STORM DRAINAGE ANALYSIS

STEPHEN LIBS CANDY COMPANY

Waterford Place Subdivision - Lot No. 7
Evansville, Indiana

BLA Project No. 197-0136-OPD

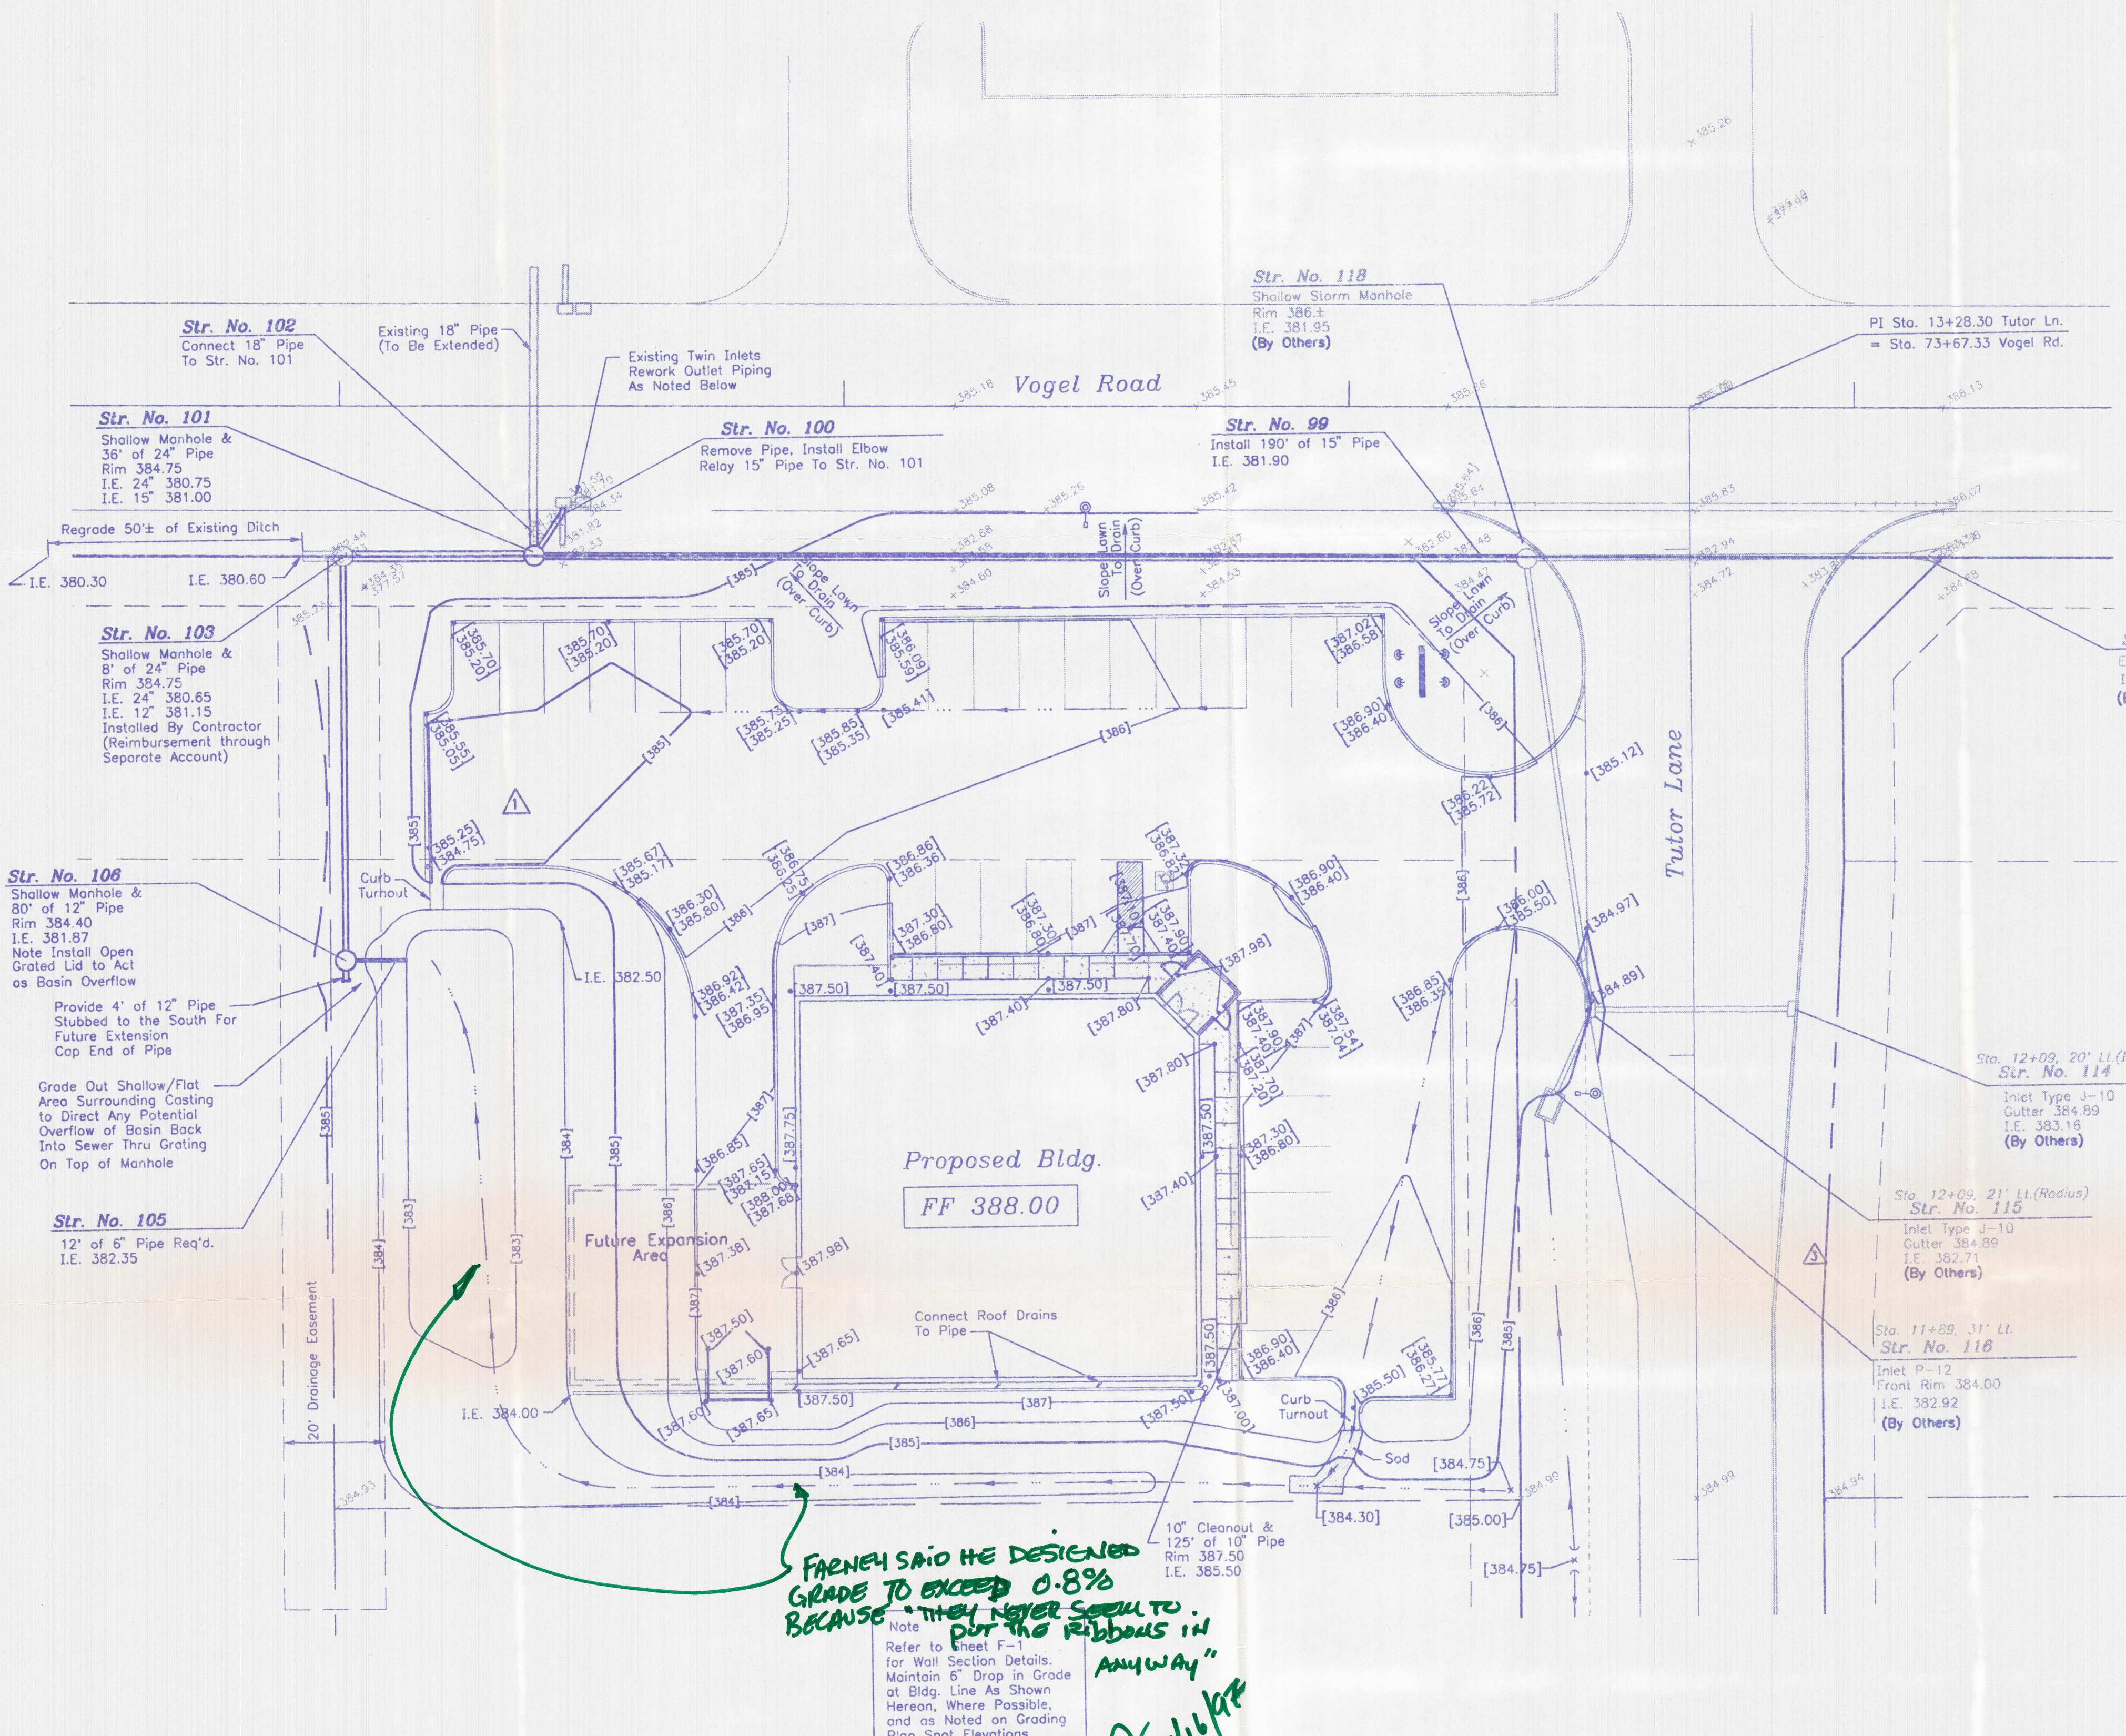
*FARNEY SAID HE DESIGNED
GRADE TO EXCEED 0.8%
BECAUSE THEY NEVER SEEM TO
PUT THE RIBBONS IN
ANYWAY*

WJG 10/16/97
